CITY OF DURHAM + DURHAM OUTDOOR AQUATICS STUDY

WHEELS FUN PARK RINK - CODE ANALYSIS

AUGUST 19, 2022

Wheels Recreation Center

KITCHEN + DINING

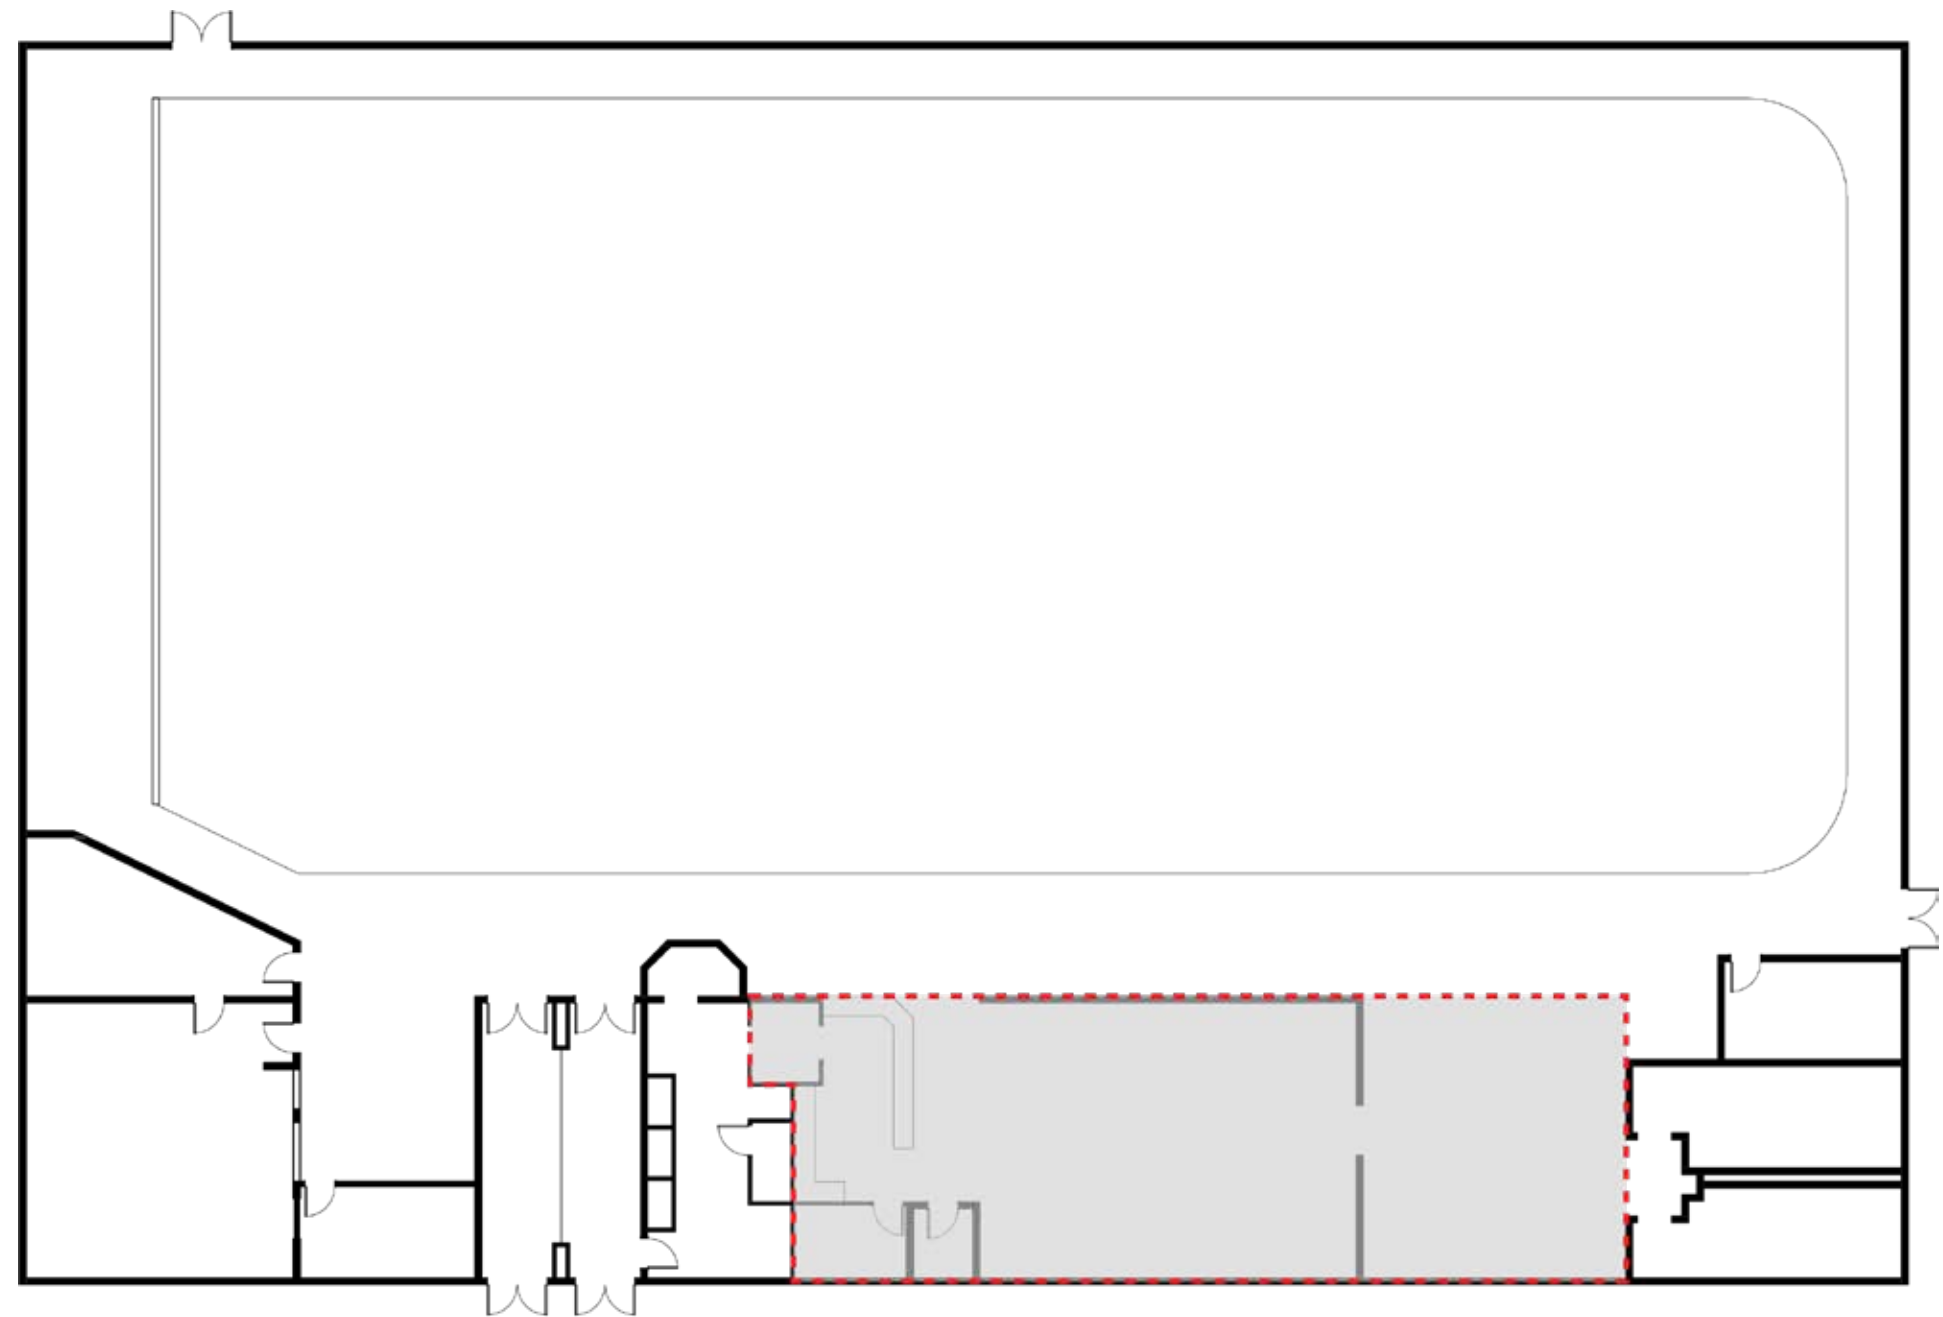
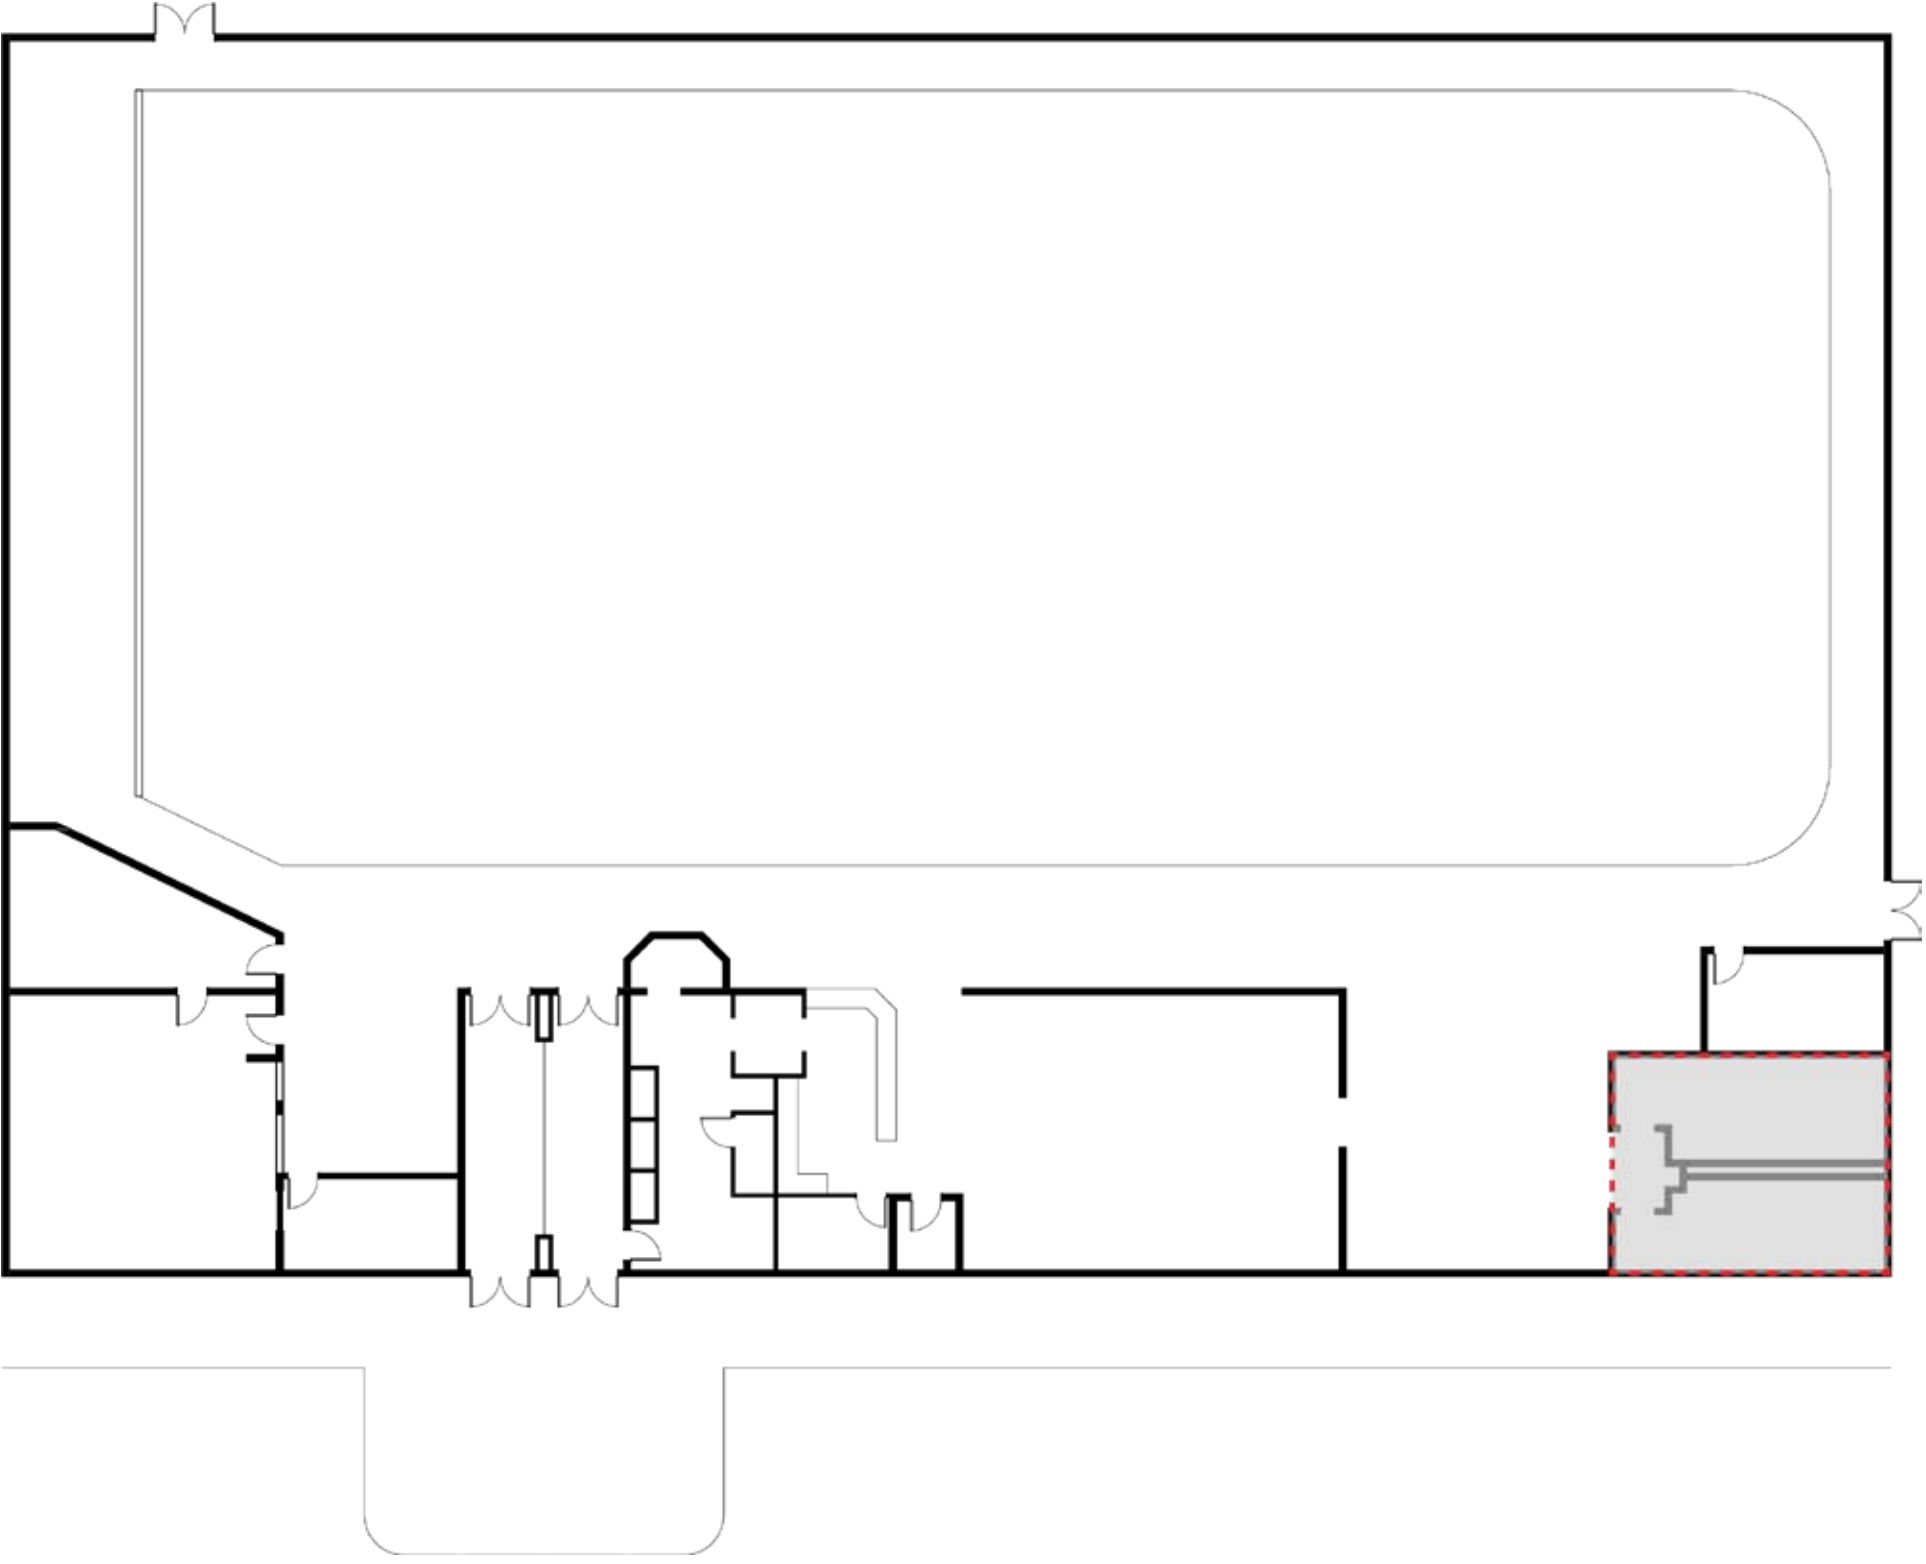
- Service counter height exceeds the maximum height, will need to be lowered to no higher than 36". [2017 ICC A117.1 - Section 904]
- The kitchen hand wash sink exceeds the required 34" height maximum and does not have the proper insulation to protect against leg contact. [2017 ICC A117.1 - Section 606]
- The kitchen hand wash sink also requires 15" clear from the center of the fixture. The adjacent cabinet will require to be shifted. [2017 ICC A117.1 - Section 306]
- The kitchen hand wash sink requires a faucet fixture with levers rather than turn knobs. [2017 ICC A117.1 - Section 309]

- Prior to opening, the kitchen will need cleaning and renovation preceding approval from the proper Health Department officials.
- Door hardware on each of the two doors in the kitchen area will need to be replaced from knobs to levers. [2017 ICC A117.1 - Section 309]

- Water Cooler does not meet accessibility requirements. The required floor space in the alcove is 36" wide. This will need to be relocated and add another water cooler. [2017 ICC A117.1 - Section 305]

RESTROOMS

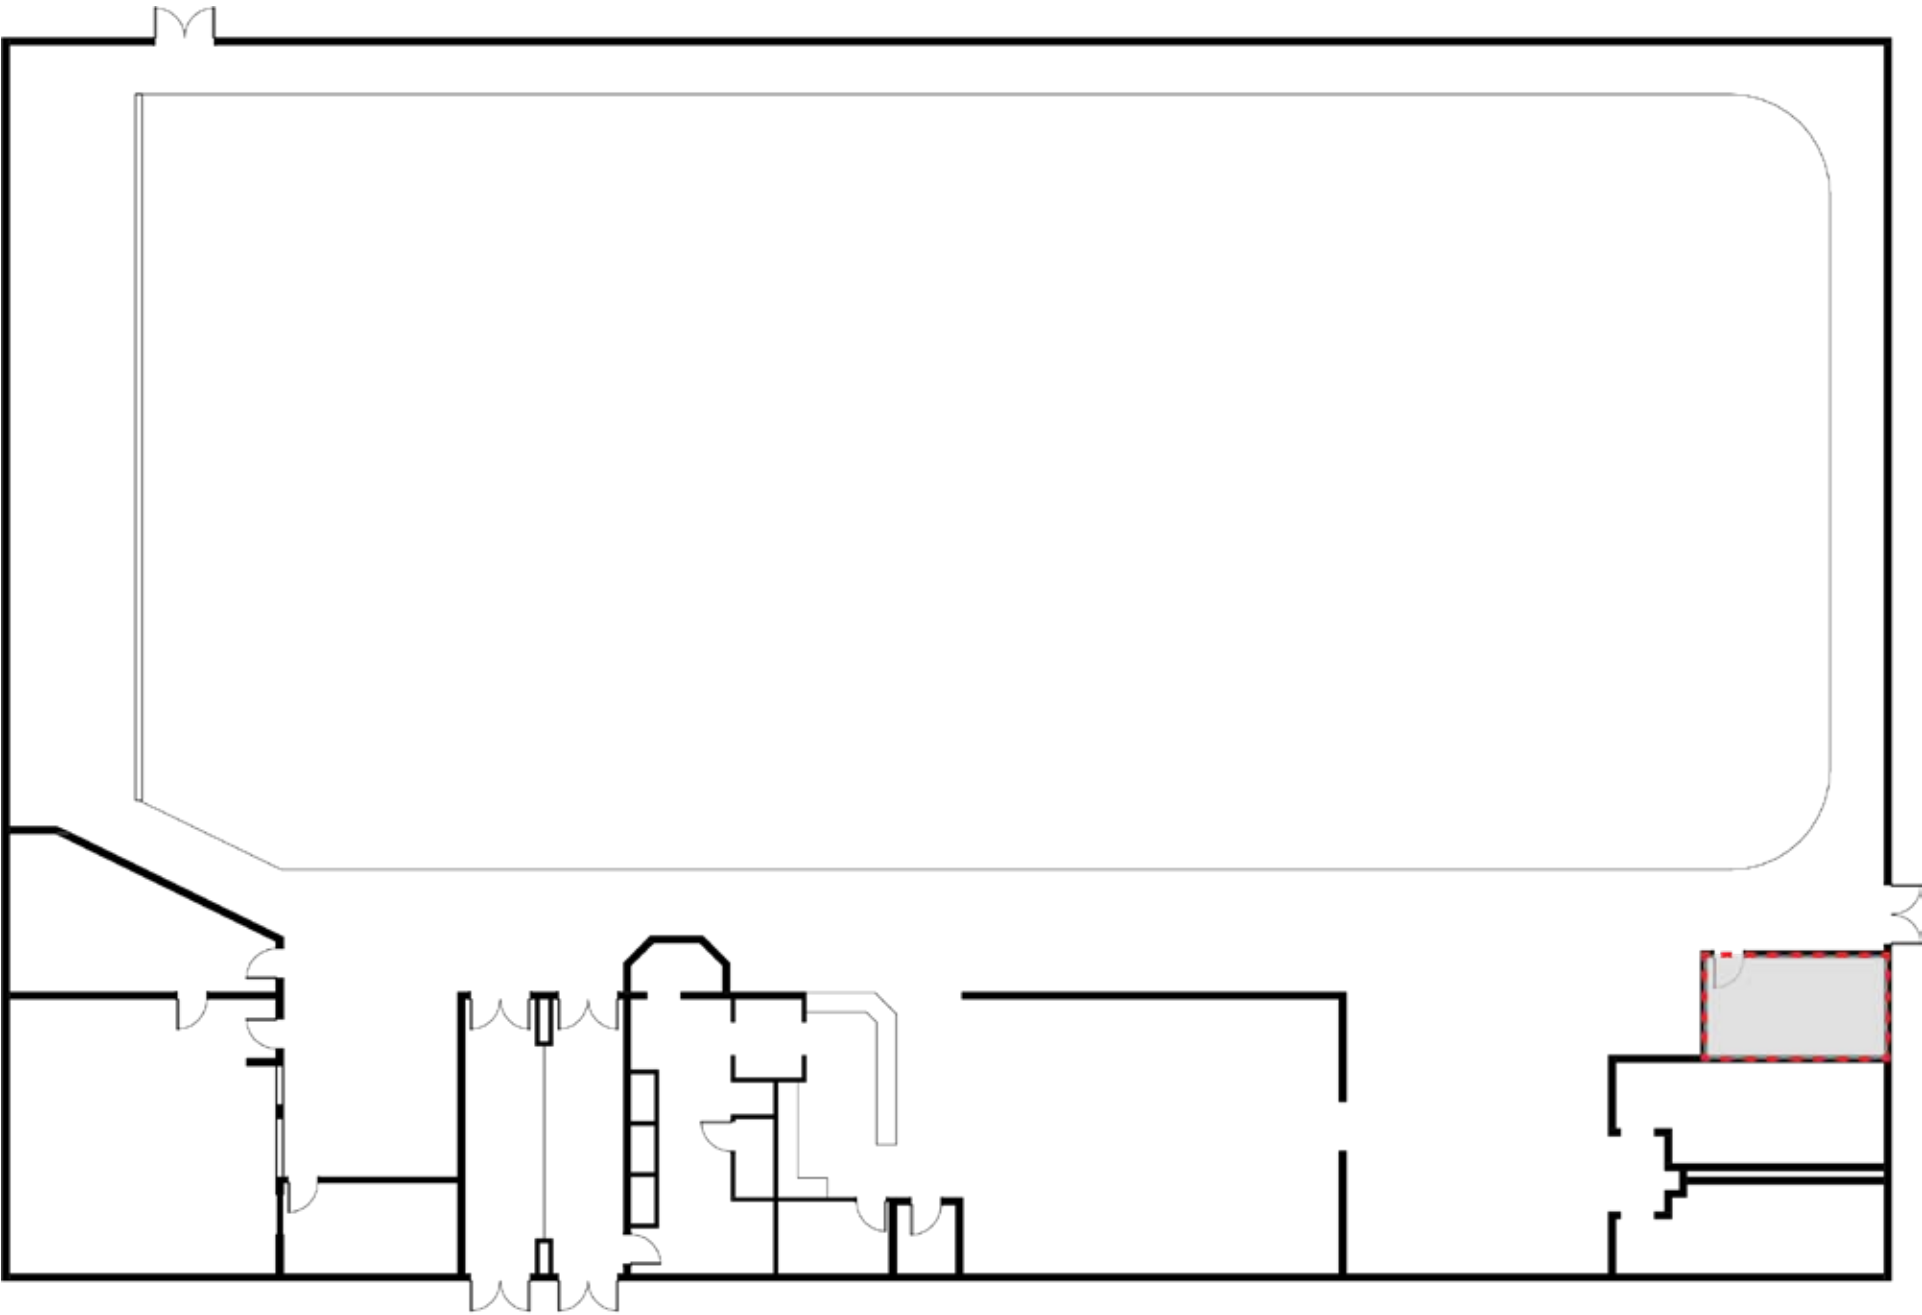
- Lavatory height in both mens and womens restrooms exceed the accessible height. Will need to be lowered at or below 34".
[2017 ICC A117.1 - Section 606]
- There is no way-finding signage for those with sight-limiting disabilities. [2017 ICC A117.1 - Section 703]

ELECTRICAL ROOM

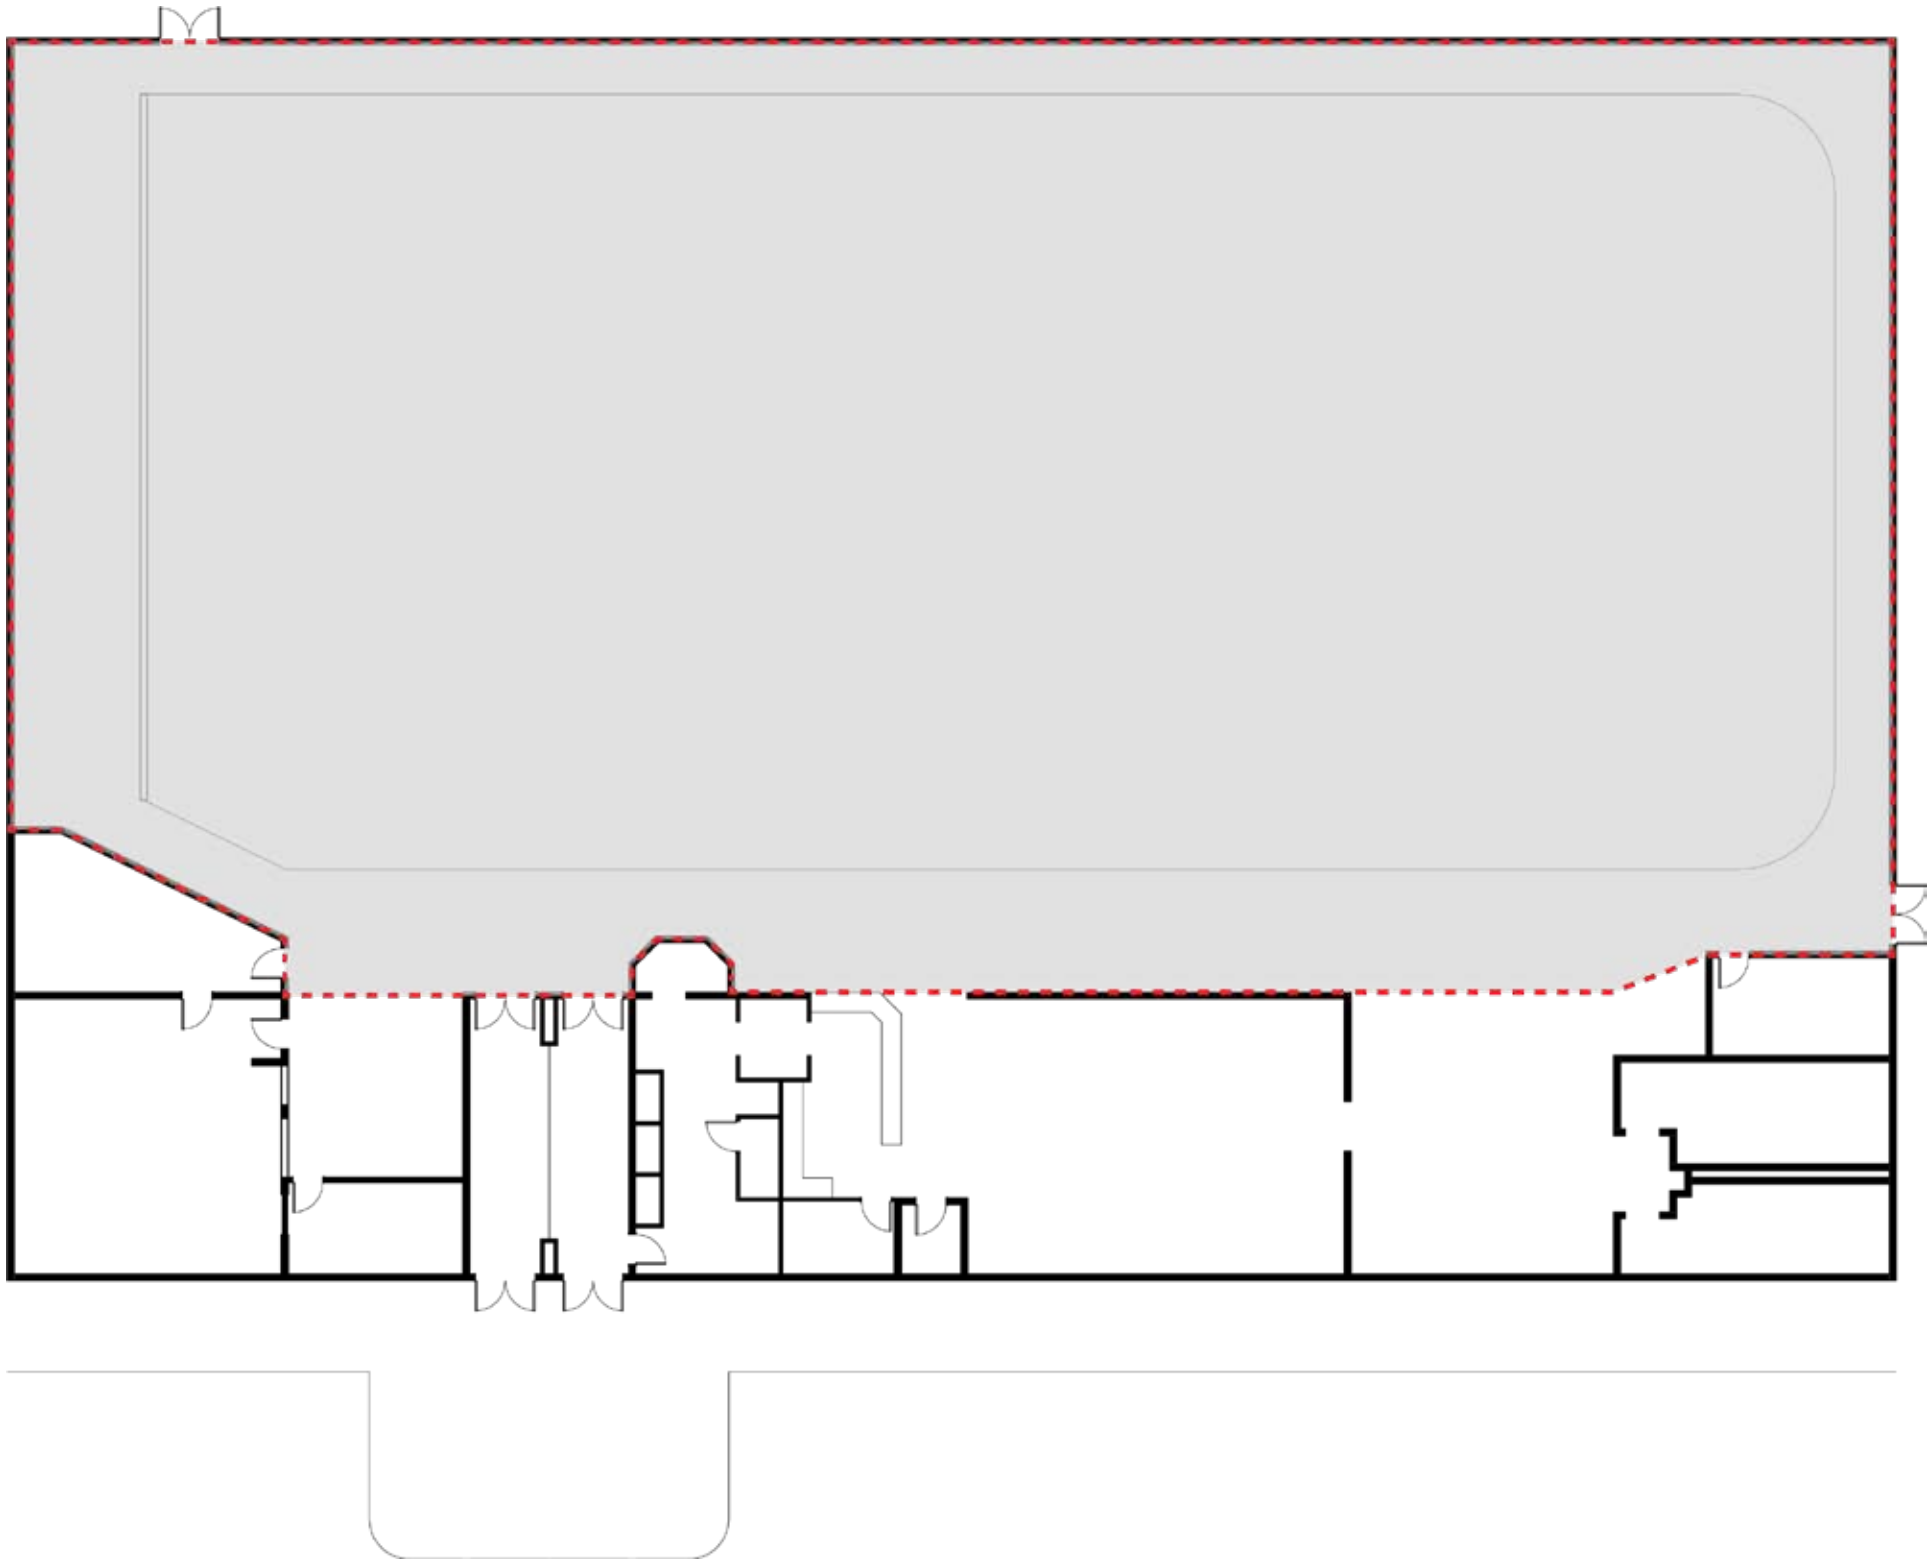
- While there are no accessibility issues regarding the electrical room, there is a concern with the building seal at the electrical conduit.
